Section 4.55(1A) DA14/0932.03

FDC Construction (NSW) write to you on behalf of our client, St Mary's Rugby Leagues Club (the applicant), in lodgement of a section 4.55(1A) application for minor modifications to the approved Western Foyer at St Mary's Rugby Leagues Club, Forrester Road St Mary's.

**RE: St Marys Leagues Club – Western Foyer Entry DA14/0932.03
Stormwater Drainage Amendment of Approved Scheme**

Attachment 1: Annotated copy of approved drawing C05 P4 prepared by Taylor Thomson Whitting.

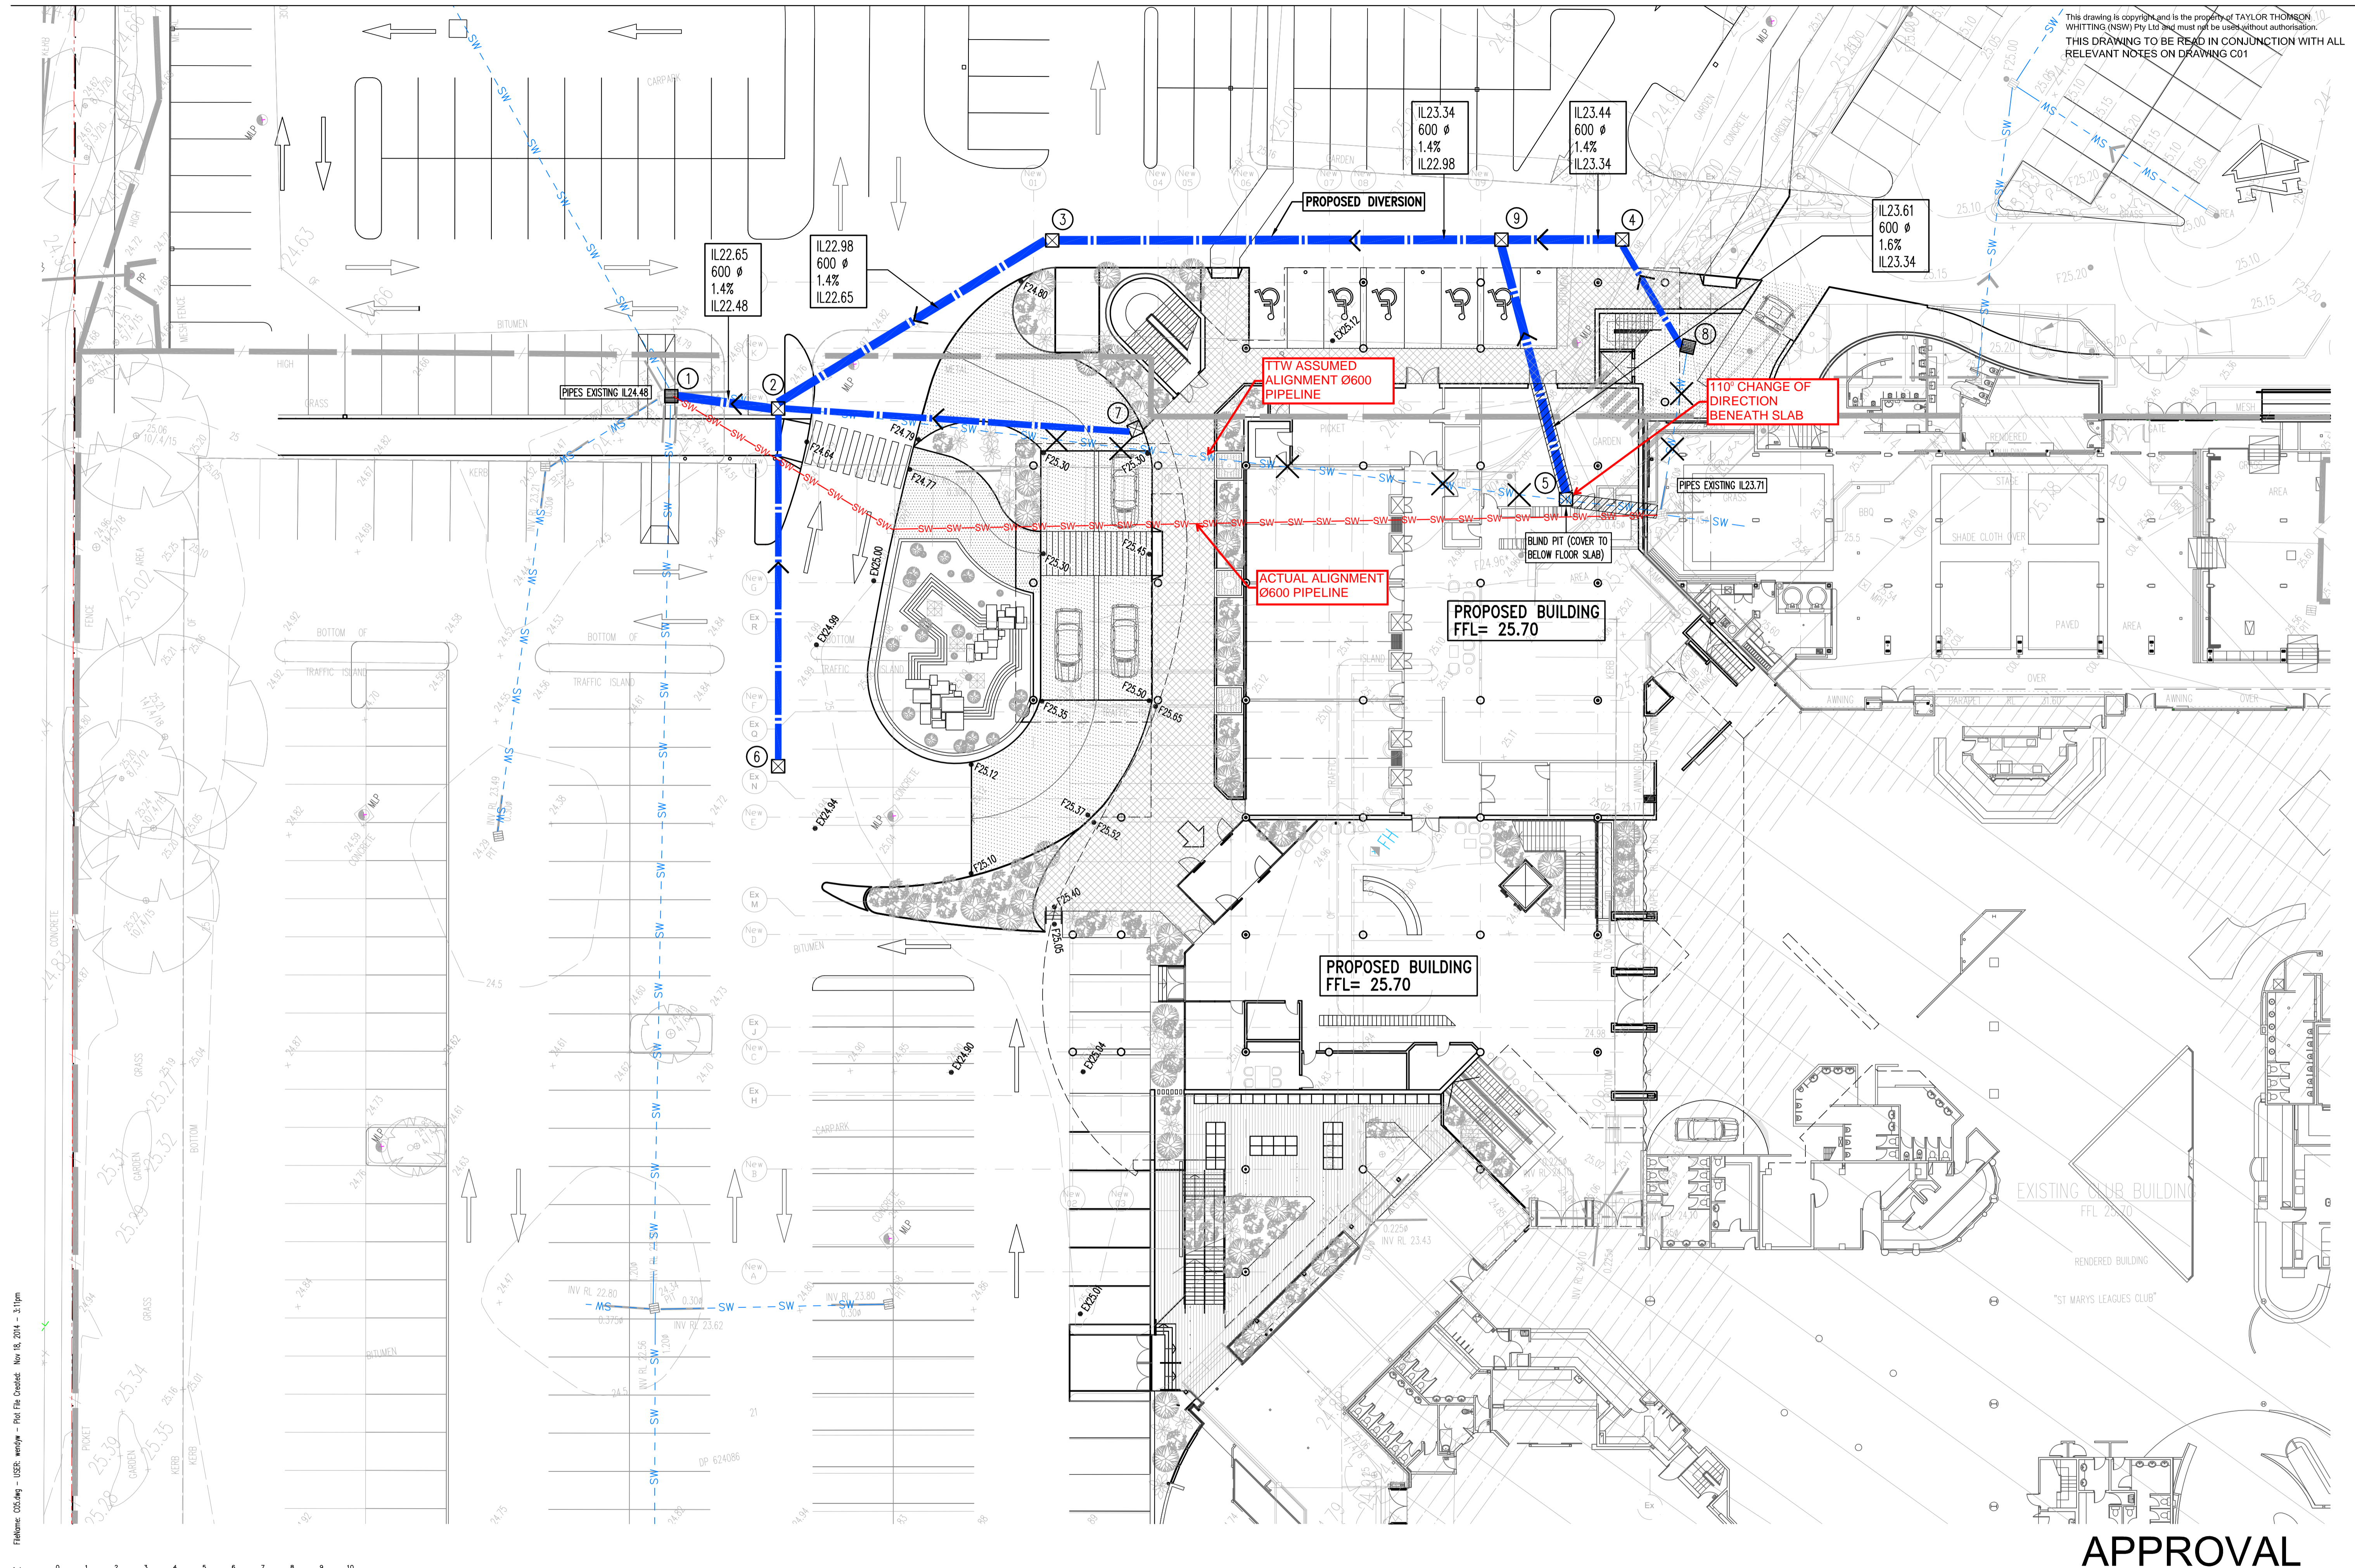
The approved plans depict an incorrect alignment of an existing Ø600 RC pipe. A diversion of the pipeline has been proposed, based on this incorrect assumption. Furthermore, the proposed diversion introduces a "blind" junction pit beneath the floor turning through an angle of 110°.

Subsequent site investigations utilising CCTV have shown the pipeline follows an alternate alignment. The actual alignment of the Ø600 pipeline has been drawn over the approved plan

and is attached (Attachment 1). Further investigation has revealed that the pipeline is satisfactory condition and has adequate capacity to convey flows post development works.

Attachment 2: Alternate Stormwater Management Plan drawing C04.01 Rev A prepared by Northrop Consulting Engineers.

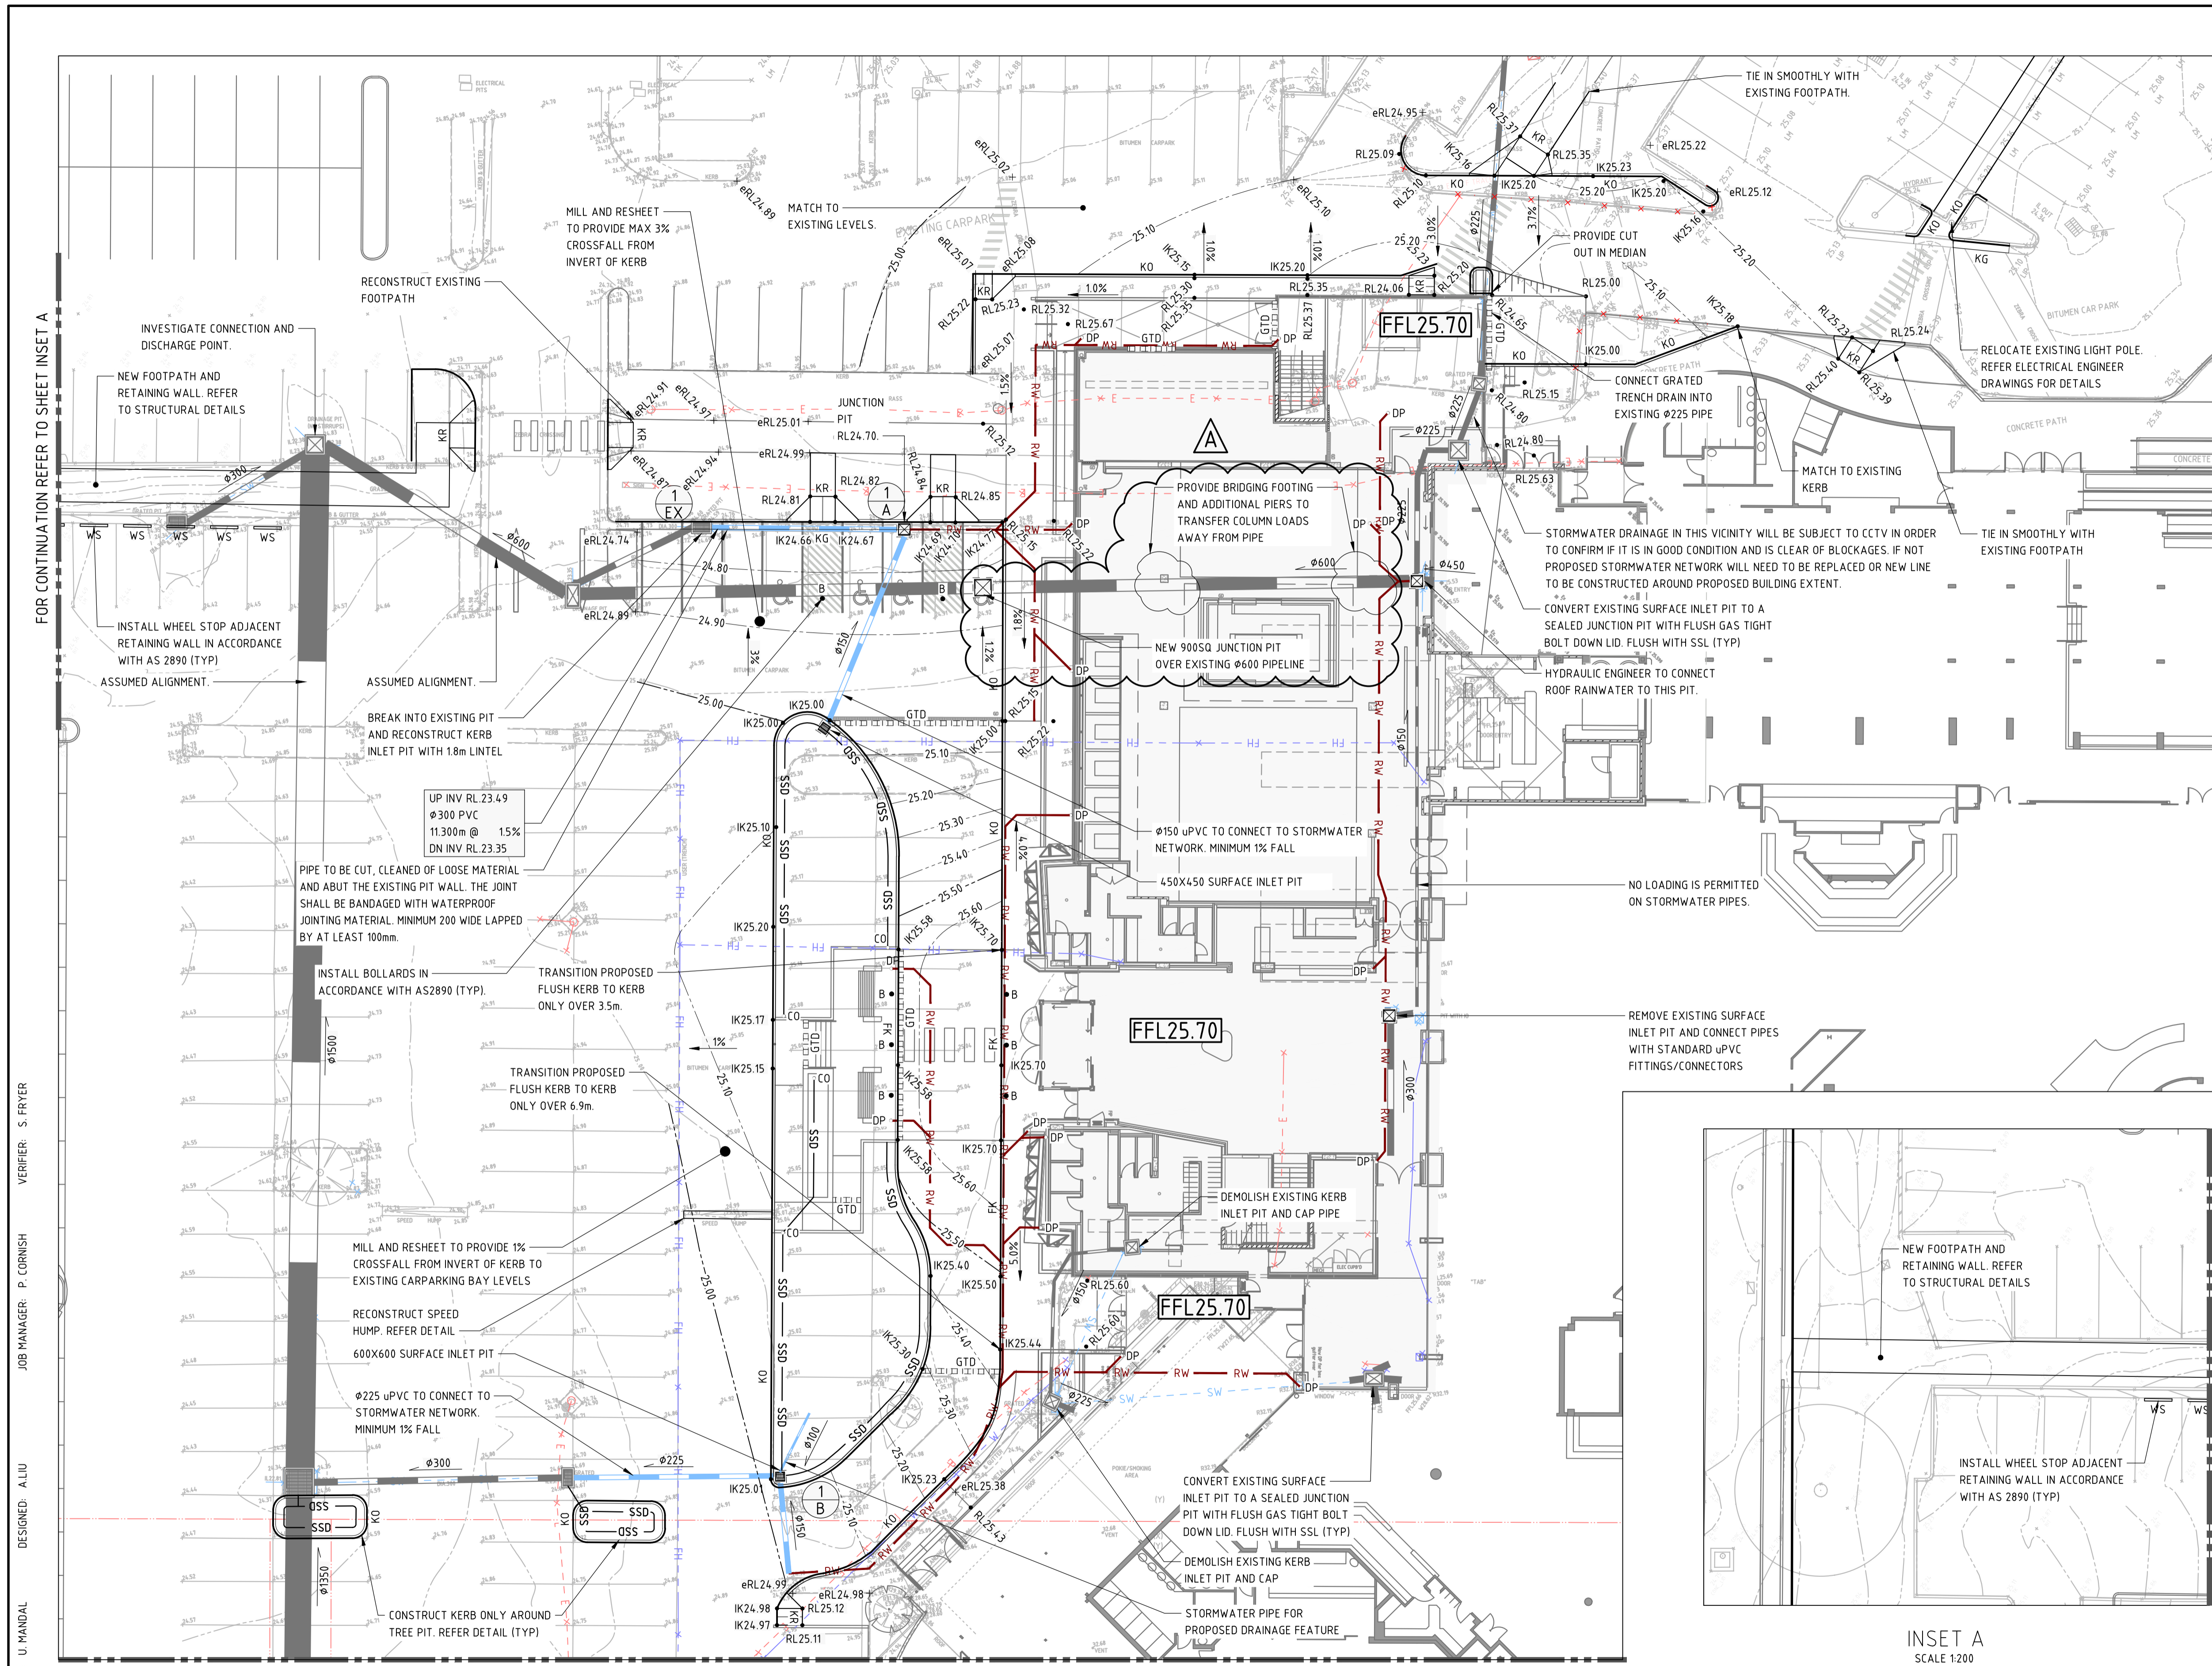
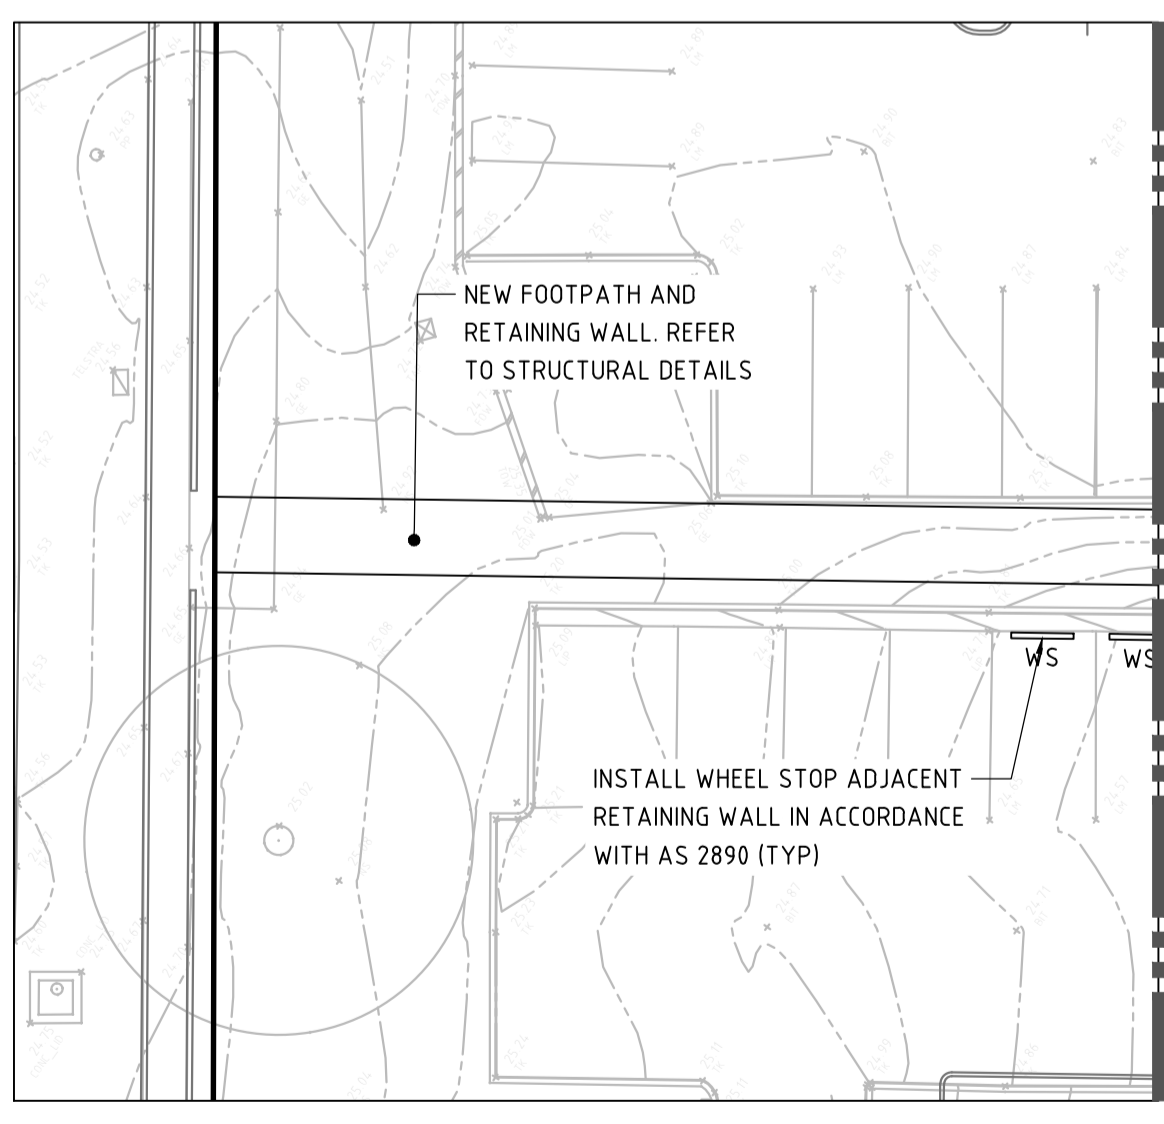
Considering the above an alternate scheme is proposed which is shown on Northrop drawing C04.01 Rev A (Attachment 2). This scheme maintains the existing alignment of the Ø600 pipeline and thus avoids the need for a blind 110° junction pit, which has a higher risk of blockage than a system without a change of direction. Considering the difficulty of accessing the blind pit once the floor to the new building has been constructed over, a more reliable system is created by maintaining the original Ø600 alignment.

The Northrop scheme also provides an additional access pit outside of the western building line. This pit will provide straight line access to the portion of pipeline under the building facilitating maintenance operations by CCTV or water jetting. A Ø150mm diameter inspection opening is proposed at the interface with the existing building to provide an additional access point for water jetting or CCTV operations.

- the same connection point to the existing system is maintained
- pipe size is maintained
- an additional access pit near the building line is provided to facilitate access.
- The new building structure can be designed such that no building loads are placed on the Ø600 pipeline beneath the building.

On this basis we are seeking to modify Condition 45 of DA14/0932.03 such that it directs the stormwater water drainage system to be installed in accordance with Northrop drawing C4.01 Rev A.
